VILLAGE OF HOMEWOOD

MEMORANDUM

Topic: Case 26-01: Comprehensive Sign Plan/Signage Appearance Review for Raising Cane's Restaurant, 17601 Halsted Street

Figure 1: Proposed Monument Sign

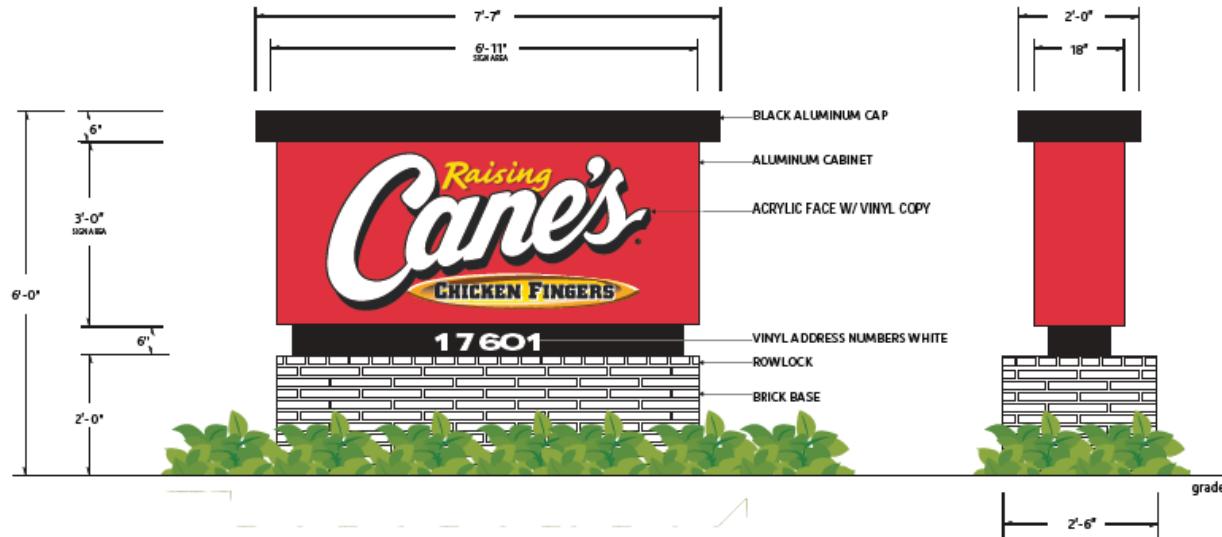
The applicant has proposed a new monument sign on the western frontage of the property along Halsted Street. The new sign will be constructed on top of the base of the existing monument sign on the site, which was used for Freddy's Restaurant. This site is permitted to have one (1) monument sign per Section 44-10-06 (Commercial Signs) of the Zoning Ordinance. The double-sided sign will have a total of 46 s.f. of sign copy (23 s.f. on each side, perpendicular to Halsted Street). The sign will be a total of 6' in height, including the existing brick monument sign base. The new sign will be constructed of an

aluminum sign cabinet with acrylic and vinyl sign faces. **The proposed monument sign meets all zoning requirements for this type of sign. An Appearance Review is required for any new monument sign construction under the newly-adopted 2025 sign code.**

The applicant plans to remove the existing custom aluminum cabinet which was constructed for Freddy's Restaurant.

Figure 2: Examples of Proposed Wall Signage

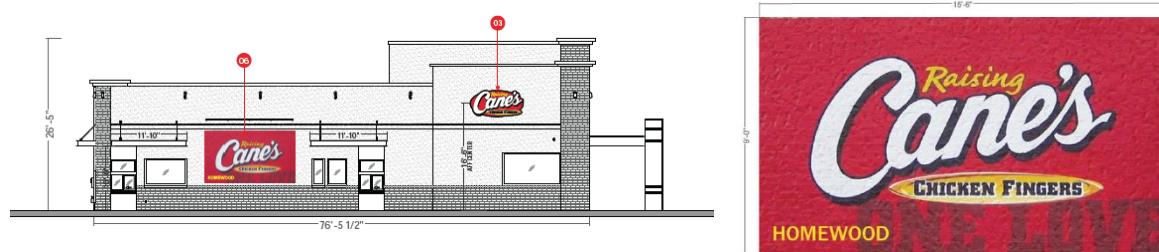
The applicant has proposed one (1) aluminum cabinet wall sign on each of the four (4) facades of the building. The applicant has also proposed one (1) additional aluminum panel wall sign on the south (interior side) elevation of the building. The Zoning Ordinance allows one (1) wall sign per frontage for property in the B-4 zoning district where the subject property is located. Per Section 44-10-06 (Commercial Signs) of the Zoning Ordinance, signs are permitted on the west (front) and north (exterior side) elevations of the building. **The applicant has requested a modification through the Comprehensive Sign Plan review to allow for two (4) additional wall signs – see *Modification Request* below.**

- No more than 130 s.f. of total wall signage
- No more than 6 wall signs on the entire building
- No more than 2 wall signs per elevation
- Internal illumination except where site conditions or safety concerns do not permit it
- Wall signs may only be constructed as cabinets or channel letters, and may only be mounted to walls and canopies

Figure 4: Proposed Canopy Sign

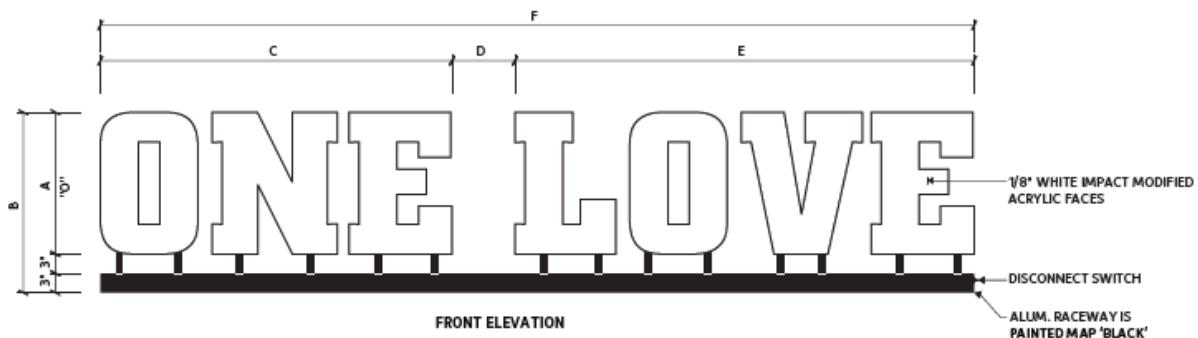
The applicant has proposed one (1) canopy sign on the west (front) side of the building. This sign will be mounted to the top of a new canopy structure located over an outdoor dining area. This sign will be comprised of individual aluminum cabinet letters with translucent acrylic faces. The canopy sign is proposed to be 17.5 square feet in area. **The proposed canopy sign meets all zoning requirements for this type of sign.**

Figure 5: Proposed Menu Board Signs

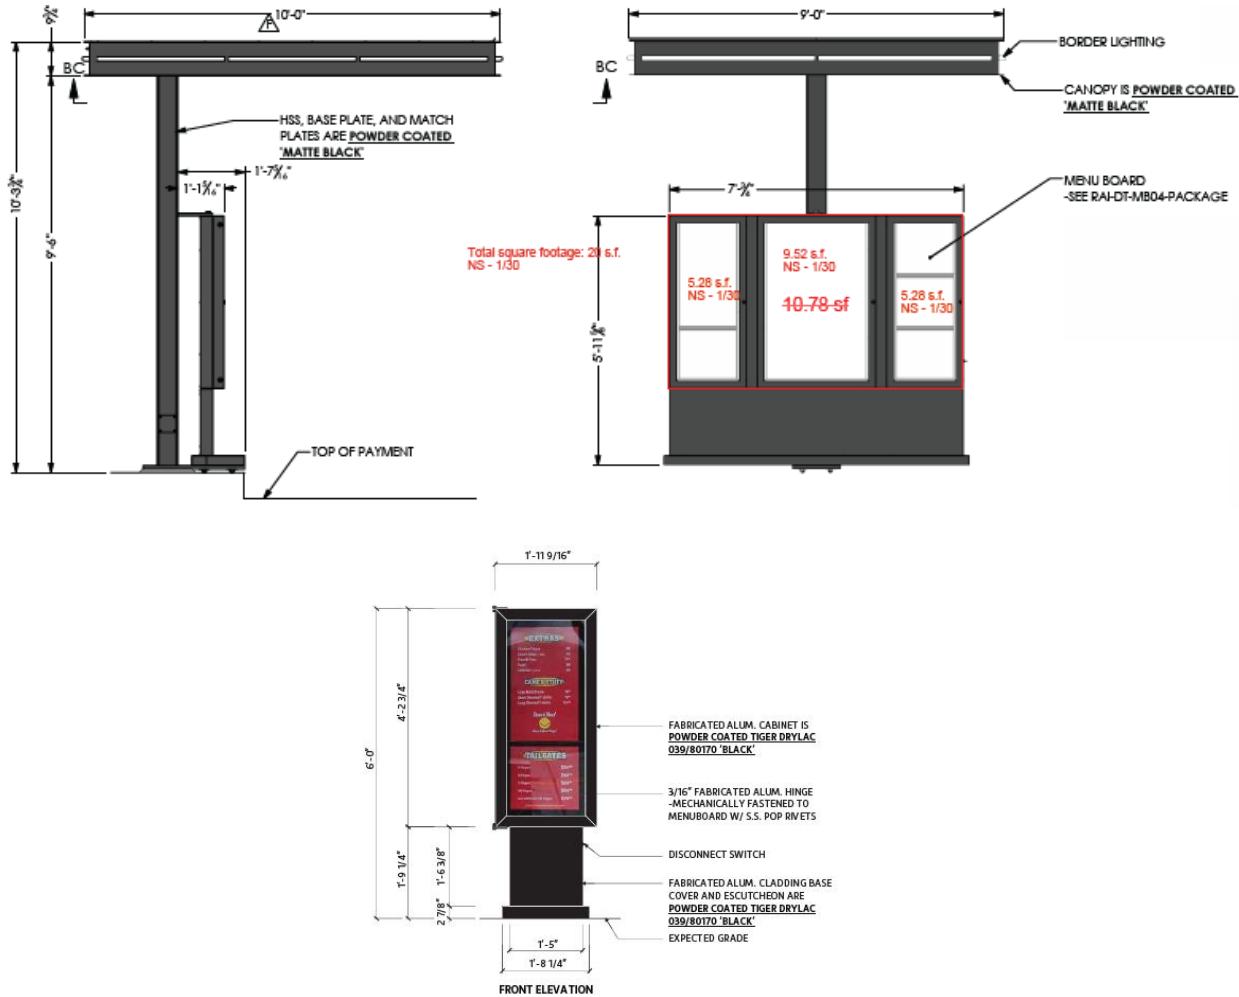
The applicant has requested three (3) menu board signs. This package of menu board signs includes one (1) "pre-sale" sign located near the entrance to the drive-through facility and two menu boards to service the two drive-through aisles. The pre-sale sign is proposed to be 12 square feet in sign area, encased in a black aluminum frame which matches other finishes across the main restaurant building. The pre-sale sign will be mounted 2' above grade on a support structure.

The two menu board signs are proposed to be 29.5 square feet in area, encased in a black aluminum frame with a matte finish which matches other finishes across the main restaurant building. These signs are proposed to be mounted to a large attached canopy, and mounted 2' above grade on a support structure. The total sign area will be 40 square feet between the two signs.

The sign faces will be constructed of translucent acrylic. The menu boards will not be digital.

The Zoning Ordinance permits two (2) menu boards per location. **The applicant has requested a modification through the Comprehensive Sign Plan review to allow for one (1) additional menu board sign.**

- No more than three total menu board signs with two speaker poles
- No additional size permitted for the pre-sale menu board
- No additional size allowed for menu board signs
- Two main menu boards should include a matching attached canopy not to exceed 10' 4" in height
